Point Beach Nuclear Plant, Units 1 and 2
Dockets 50-266 and 50-301
Renewed License Nos. DPR-24 and DPR-27

License Amendment Request 261
Extended Power Uprate
Response to Request for Additional Information

LICENSE AMENDMENT REQUEST 261 EXTENDED POWER UPRATE RESPONSE TO REQUEST FOR ADDITIONAL INFORMATION

Figure 5-1: Broken Loop Hot Leg Liquid Mass Flow Rate

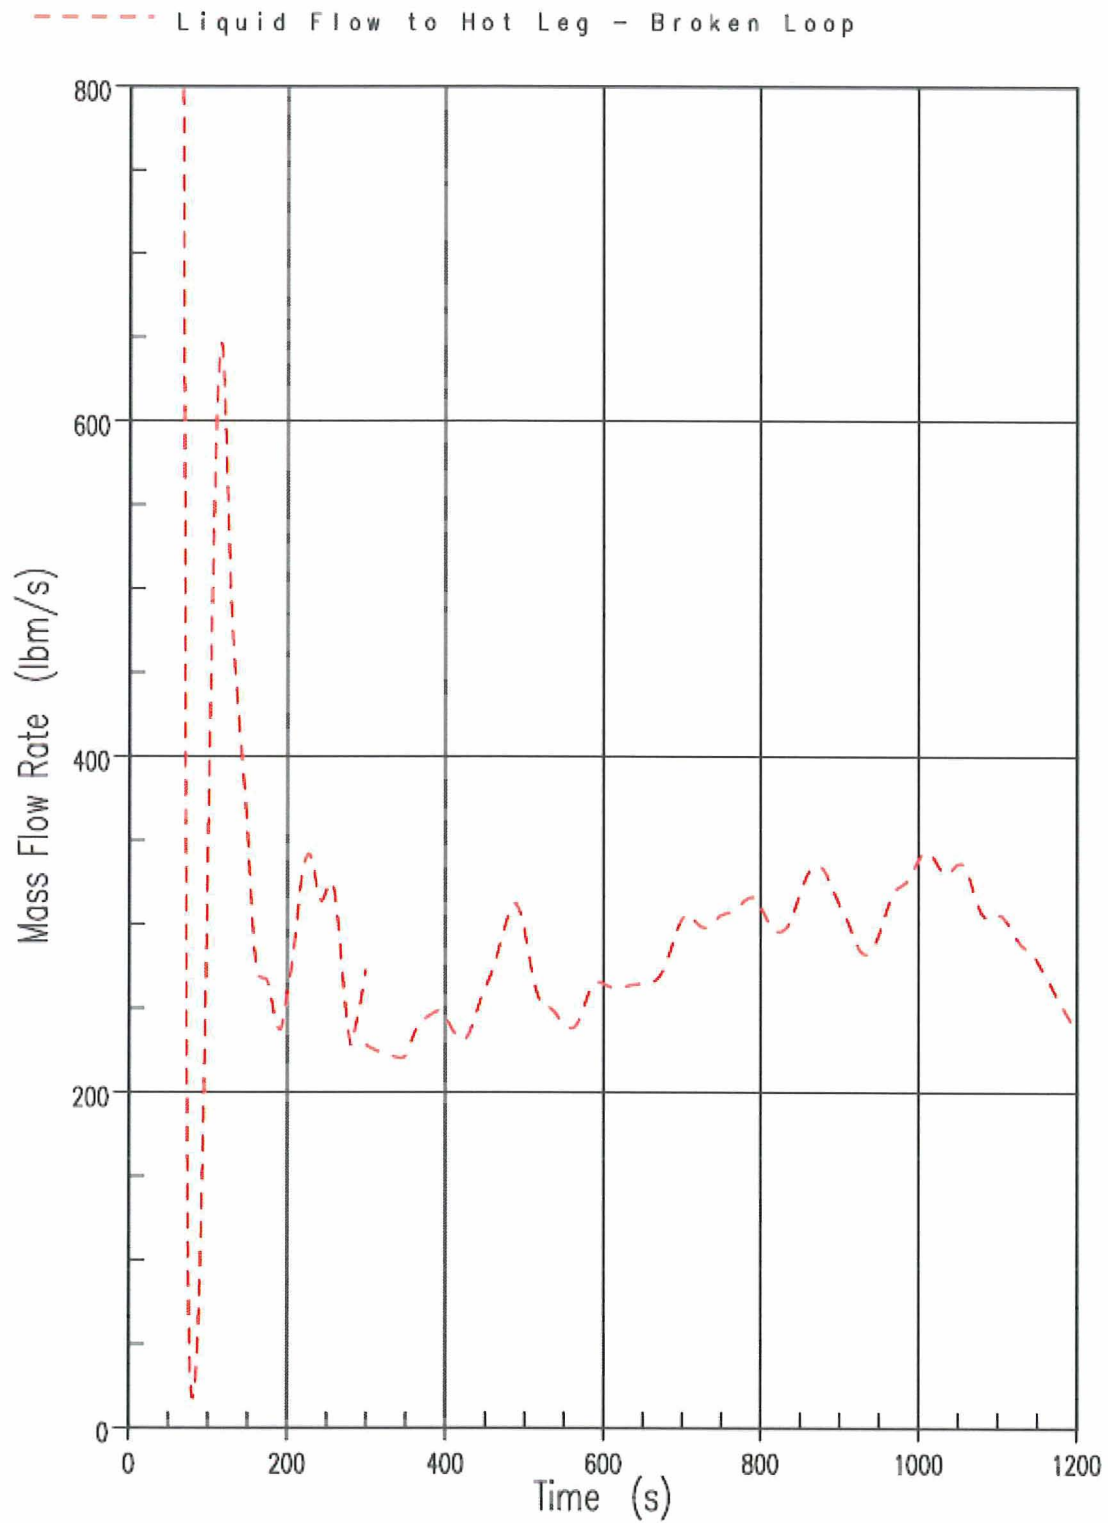
Please provide reference to the licensing report or request for additional information response providing justification of a 20 minute delay in boric acid accumulation at a recently uprated plant of similar design to Point Beach.

1. From the beginning of reflood onward, there is significant liquid flow out of the hot leg break (Figure 5-1).
2. After 100 seconds, UPI water travels down into the low power, outer core regions. At the same time, there is significant upward flow in the center, high power core region (Figure 5-2). This indicates sufficient circulation such that the core and upper plenum are well mixed. These core flow patterns are consistent with those observed in the CCTF Core-II large scale tests (Reference 4).
3. With one HHSI pump injecting to both cold legs, the SI flow to the cold leg is approximately six times the net core boil-off rate (Figure 5-3).

Because there are high amounts of liquid flow out the break, and because the core and upper plenum regions are well mixed, there is no potential for significant boric acid buildup in the core during the injection phase following a large break LOCA in the hot leg. Cold leg injected flow is much greater than boil-off during this time and this will also promote core dilution by forcing flow into the core region from the lower plenum.

Figure 6-1: Limiting Bottom-Peaked Axial Power Distribution for Average Power Rod

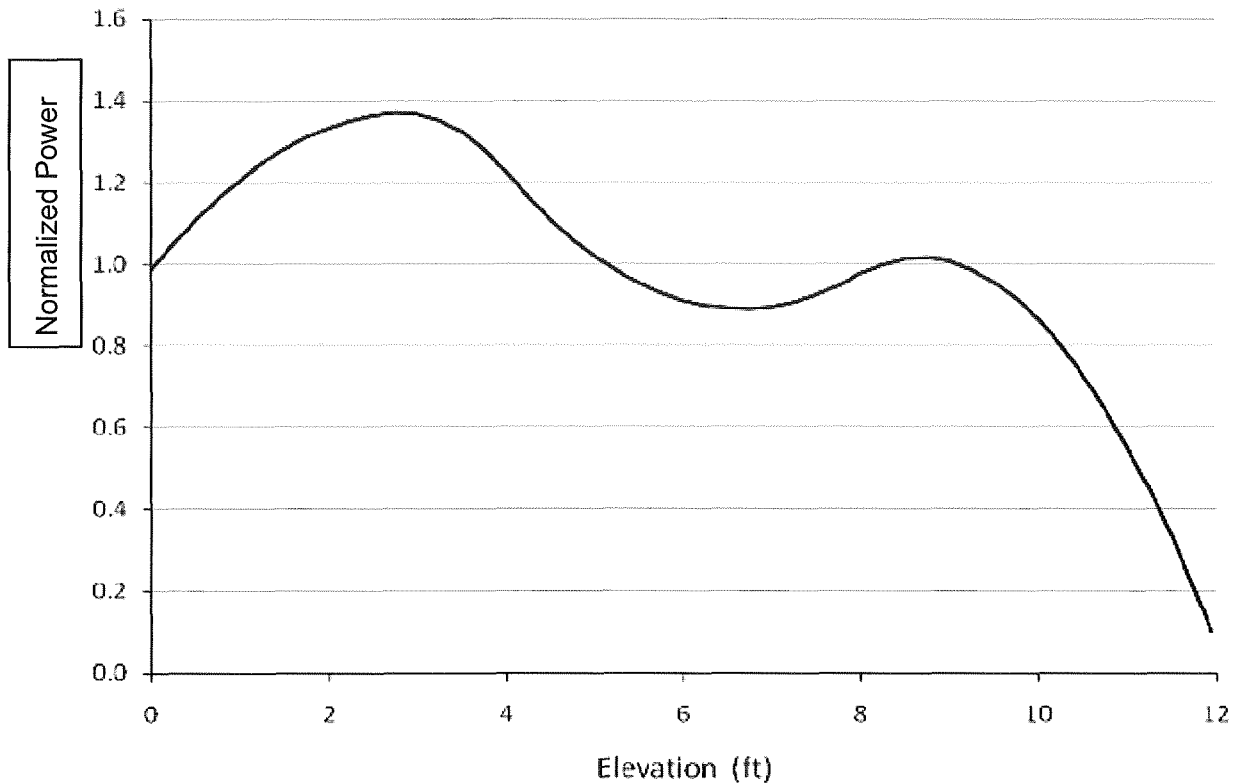
Provide a limiting bottom-peaked axial power distribution.

The limiting bottom skewed power shape data is tabulated in Table 6-1 and graphically depicted in Figure 6-1.
